Environmental Review Team Report

Indian Springs Subdivision

Killingworth, Connecticut

ENVIRONMENTAL REVIEW TEAM REPORT
ON
INDIAN SPRINGS SUBDIVISION, SECTION I
KILLINGWORTH, CONNECTICUT

Map showing areas of high risk and low risk of well-water contamination.

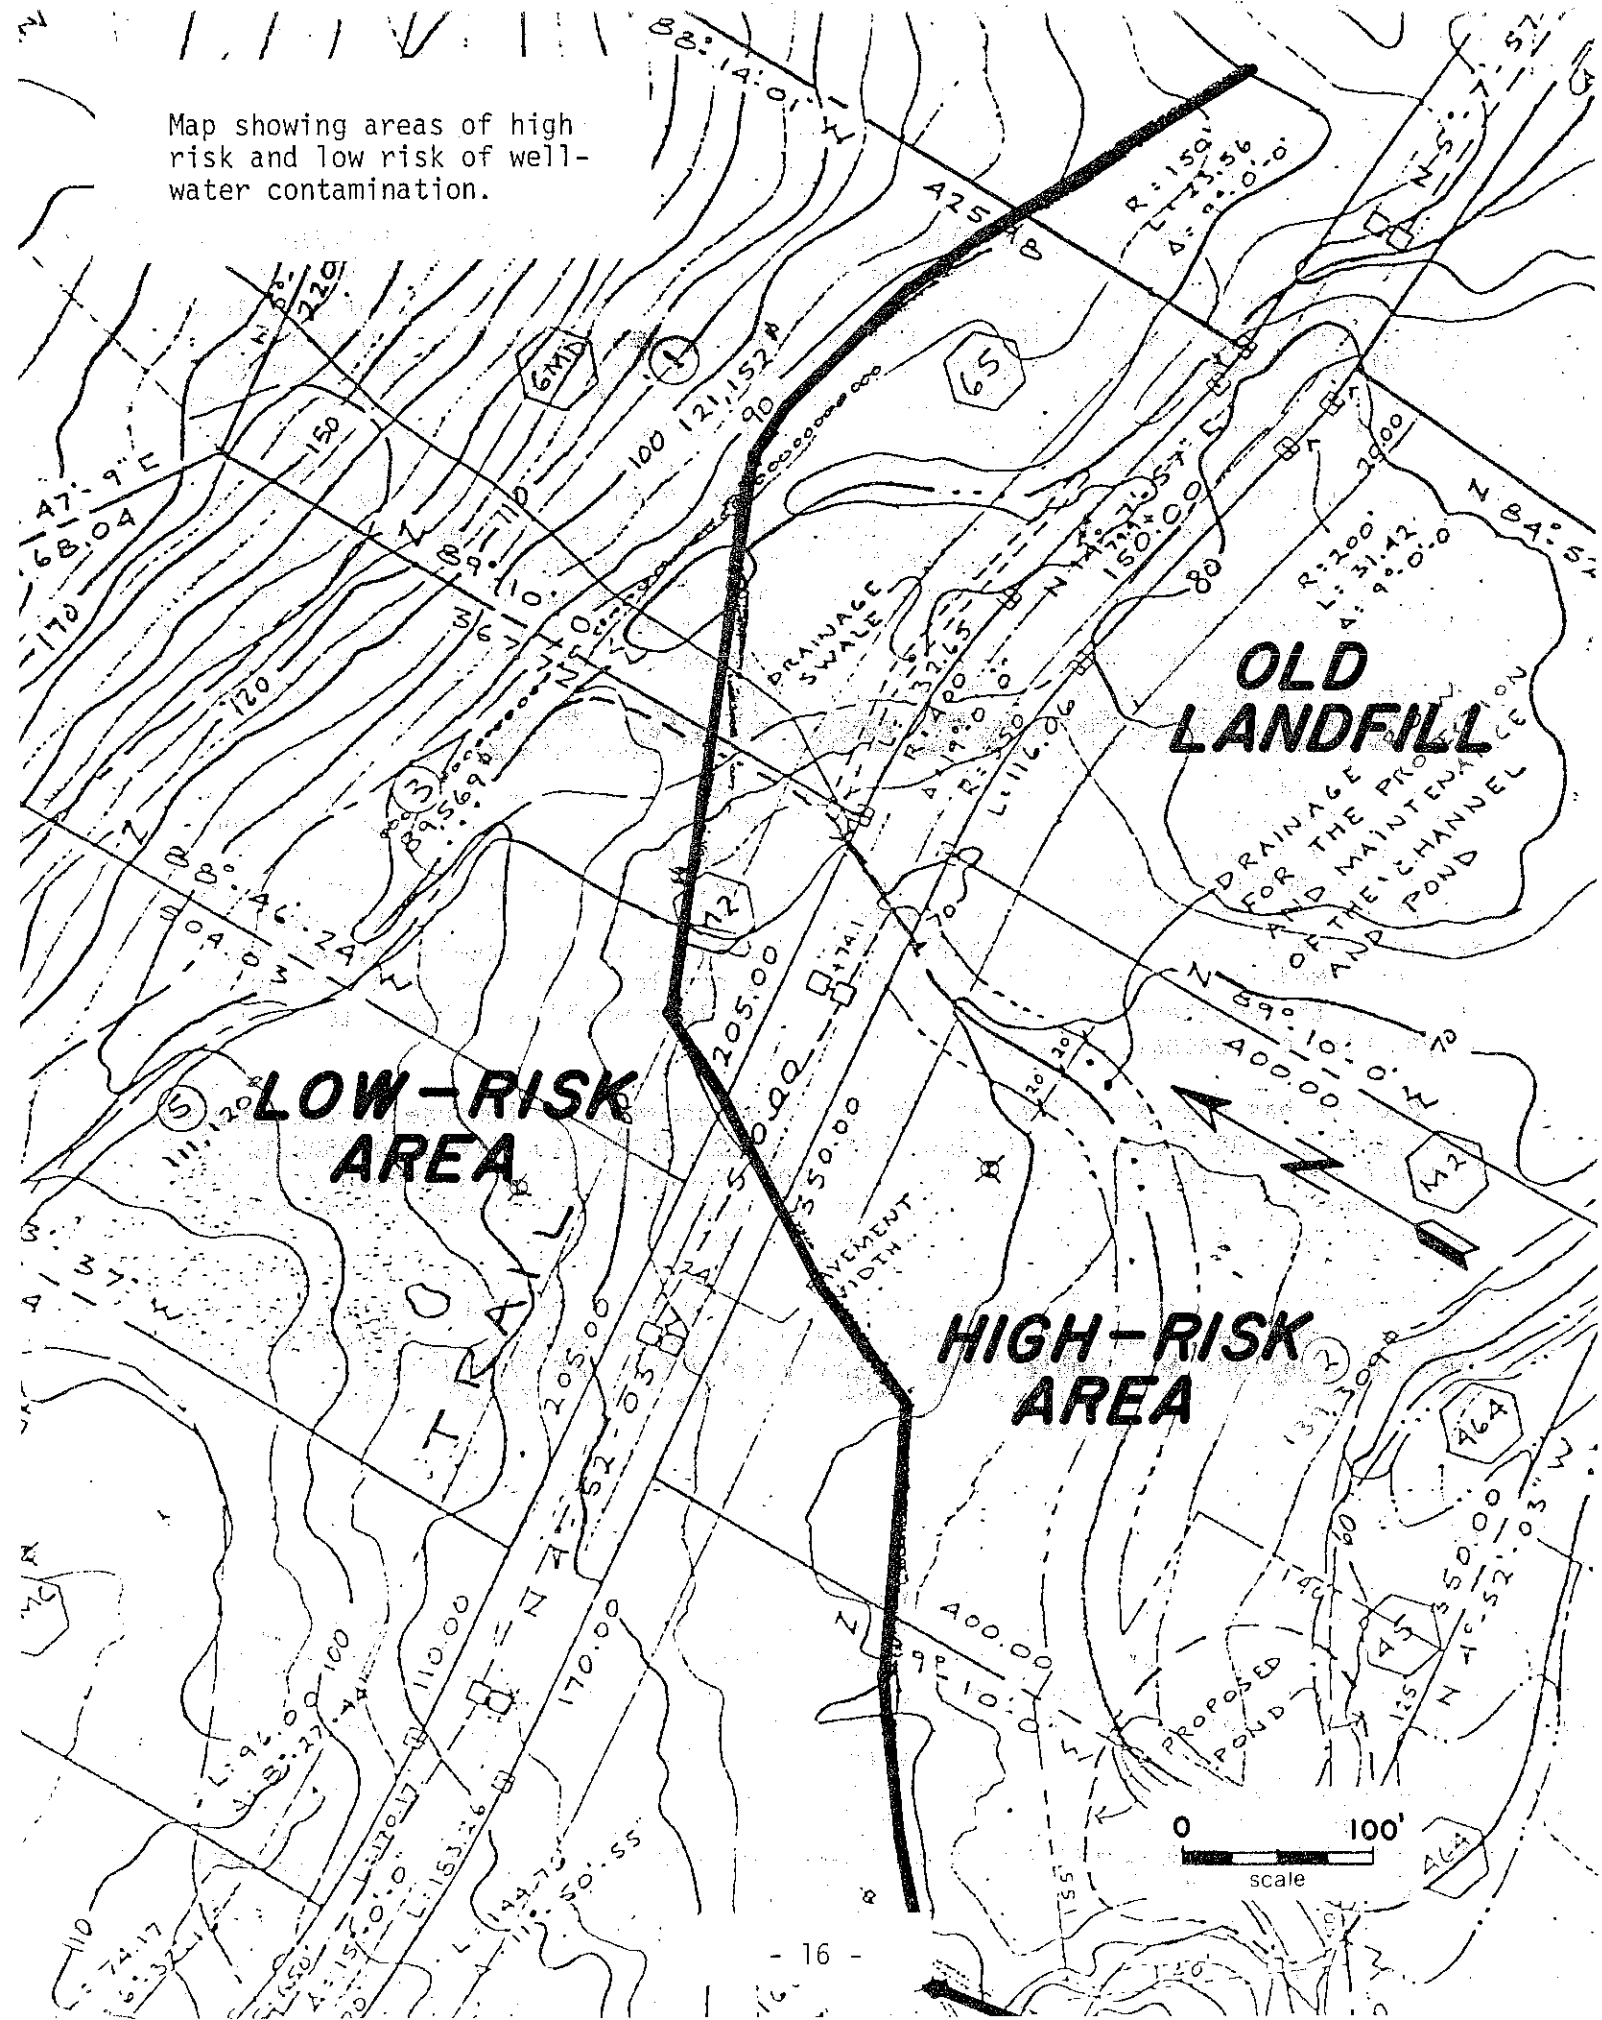
Water is proposed to be supplied to lots in the subdivision by individual on-site wells. The major concern regarding such supply is the possibility of groundwater contamination from the old town landfill, which is located immediately west of lot 1 and south of lot 2. On the basis of test well data submitted to Paul Marin, a senior environmental analyst with the Department of Environmental Protection, Mr. Marin drew a line on a map of the site that was intended to separate areas where leachate contamination of well water was likely from areas where the risk of such contamination was small. A reproduction of the pertinent portion of that map is included in this report. Mr. Marin stipulated that some wells drilled in the putatively safe zone might still be subject to leachate contamination since the directions of groundwater flow in the bedrock underlying the site could not be conclusively determined. Part of the "unknown quantity" was the orientation of fractures within the rock. A study of bedrock outcrops suggests that the principal orientation of fractures is east-southeast. Nevertheless, crosscutting fractures oriented in opposing directions probably exist, though not in the same concentration as the principal fractures.

On the basis of Mr. Marin's report and the evidence of major fracture orientations to the east-southeast, the Team concludes that a well drilled on proposed lot 2 would be subject to a high risk of leachate pollution, the risk being lowest in the northeast section of the lot; and that a well on proposed lot 1 would be subject to a moderate risk of contamination if drilled in the rocky, eastern section, and a high risk of contamination if drilled in the low-lying, western section. Moderate risks would exist for wells drilled in the western section of lot 3 and the southern section of lot 4. Other lots would be subject to only a slight risk of leachate pollution.
